City of West Linn
PRE-APPLICATION CONFERENCE MEETING
Notes
November 17, 2011

SUBJECT: Class II Parks Design Review, Willamette River Greenway Permit, Water Resources Area Permit, Flood Management Area Permit, and possible Class II Variance for stream setback, for proposed “replica” boat barn at Maddax Woods Park, 5785 River Street

Map of proposed barn area in relation to piped drainageway, overlays. Willamette River River is at top. Light blue lines are open drainageways, including Maddax Creek in the center area of the photo.

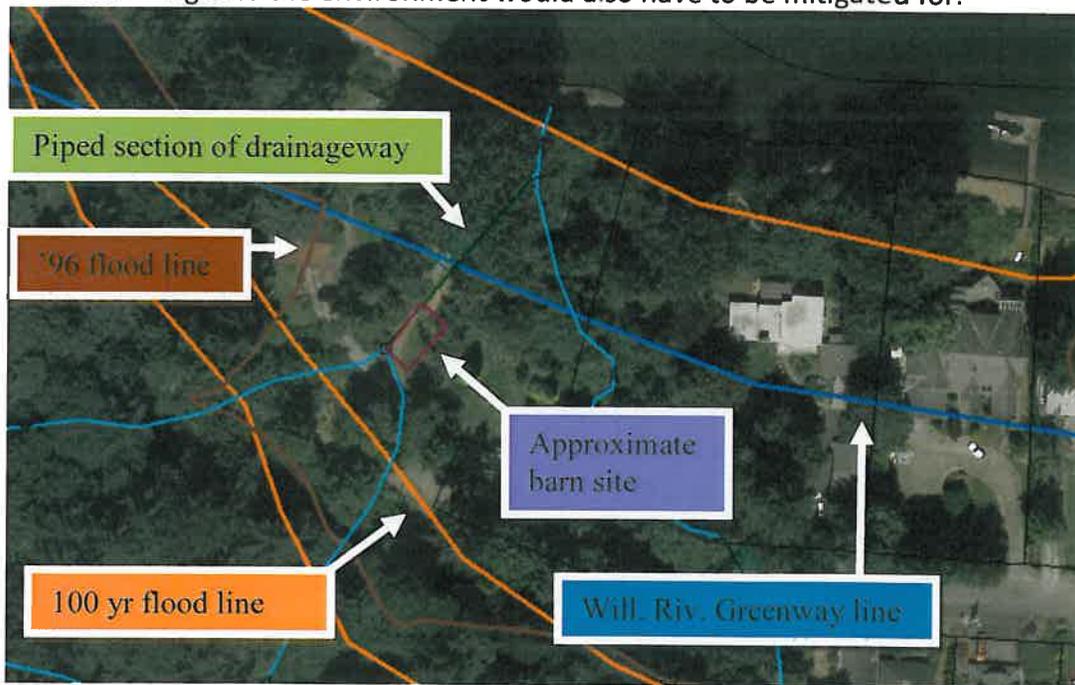
The proposed area for the building is within 100 feet of Maddax Creek (a significant riparian corridor) to the east. Per Table 32-1 in the CDC, the proposed building area is partially within the corridor transition area, so a Water Resource Area permit is required as well per CDC Section 32.025. Also a piped tributary is along the barn foundation site itself, so this must also be opened per 32.050(N) (see further discussion below for what this entails for the project). The project is within Maddax Creek's transition area, and the tributary's transition area upon its daylighting, per 32.050(E)'s measurement methods. However, development can be applied for within a transition area (and mitigated for if approved), if there are no other practicable alternatives, per 32.050(C). This means that the applicant will have to show there are no alternatives outside the transition area and that the project needs to happen, and happen at this location.

Also, the edge of the foundation is right at the underground pipe where the stream to the west and its nearby tributary have been undergrounded, starting at the house's driveway just south of the barn site. Section 32.050(N) requires that as part of a Class II Design Review, piped drainageways must be opened and their 32.050(E) setbacks respected unless the City Engineer determines that the opening of the drainageway would have a negative effect on water quality and the storm water system. The absolute minimum setback allowed is 15 feet per 32.090(C)(1) even with a Water Resources Area permit and mitigation. This may make this proposal difficult in terms of compliance with Chapter 32 unless it is determined the drainageway should not be opened or unless opening it could result in a different trajectory through this part of the site. If the barn is proposed at this location with the creek right beside it, a variance to the minimum structural setback of 15 feet would be necessary. This would be a Class II Variance. To be approved it must meet all variance criteria of Chapter 75 as well as showing that such a proposal can be made to not be environmentally damaging.

If it is determined the stream is able to be daylighted here without harming the system, the applicant shall daylight it as part of a Class II Design Review approval. Engineering's initial look at the site did not produce compelling reasons to leave the stream piped, so it may not be very likely that the division would determine otherwise when the application is under review. To be able to avoid daylighting it under this scenario, a different Class II Variance would be necessary.

Alternately the barn could be built at a somewhat different location on this part of the site so it is further than 15 feet from where the drainageway may be daylighted, avoiding the need to apply for either of the variances discussed above.

Another alternative is to daylight the stream but divert the water around the barn site in a way that allows for a minimum 15-foot setback between water and barn to be respected. In this scenario the stream, which already enters Maddax Creek just downstream from the barn site, could be diverted south of the site to enter Maddax Creek at a slightly different location on site. The feasibility of this solution would depend on how much Parks can spend or is willing to spend on this engineering project, and whether the solution would be environmentally damaging.
